RE: SEQRA
Review of Visual, Community Character,
and Alternatives
Depot Hill Farm DEIS
Town of Amenia
Dutchess County, New York

My office has conducted a detailed review of Visual (Section 3.7), Community Character (Section 3.21), and Alternatives (Chapter 5) of the Draft Environmental Impact Statement (DEIS) for Depot Hill Farm. This review focused on substantive issues regarding environmental impacts of the project pursuant to 6 NYCRR Part 617.

Figure 1: Proposed site plan with the SPO shown as hatched, along with other elements

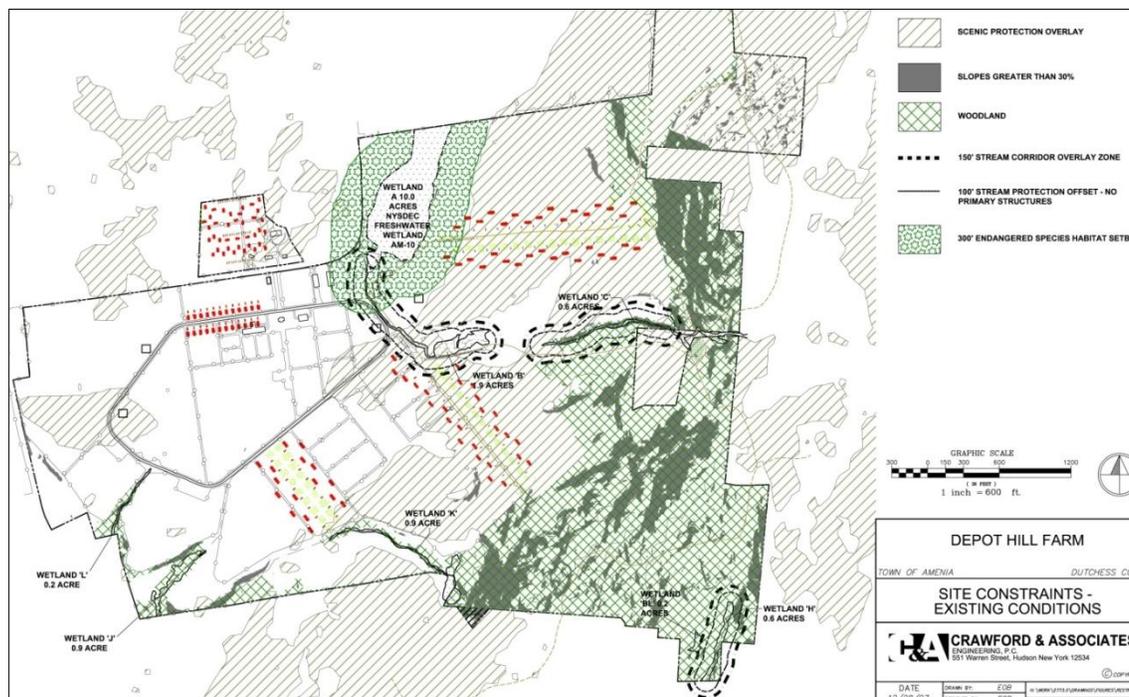
The SPO includes the hatched areas on the above map, which has been superimposed with the development proposal. Virtually all of Neighborhood 1 and 2 are shown inside the SPO, while small portions of Neighborhood 3 and 4 are also inside the SPO.

While the intention of the SPO is excellent, its implementation through the Town's zoning does not meet its intention, specifically for the Ridgeline Visual Protection Zone. The overlay concept only addresses *target* scenic area (i.e. the ridge) and does not address the viewshed (i.e. the area in-between a viewer and the target.) For the scenic roads component of the SPO--which does not include Depot Hill Road--the overlay concept works fine because the viewshed and the target are essentially the same. For ridges, which can be visible from long distances, however, an overlay concept does not work well considering the intention.

Figure 2: Diagram showing hypothetical obstructions to an SPO that are not in an SPO

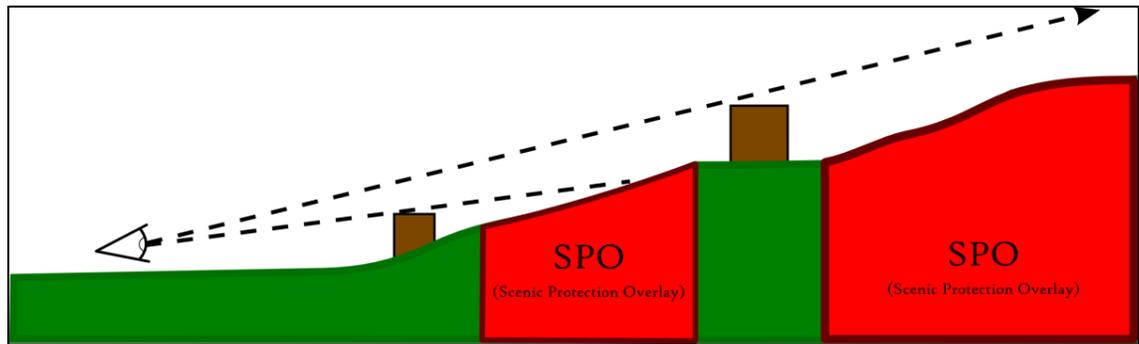
The entire viewshed is important when viewing the target. By preserving or protecting only the target, a view to a target can be significantly impacted by activities that occur outside of the protected area. For example, consider the following diagram:

A viewer (represented by the eye) can have views to a target area completely or partially blocked by development that occurs outside the protected area. This weakness is exacerbated by the fragmented nature of the Town's current Ridgeline Visual Protection Areas, which are not uniform, but have holes and are irregularly shaped. This finding is more than just theory, but has real application to this development proposal. Consider, for example, Viewpoint 4:
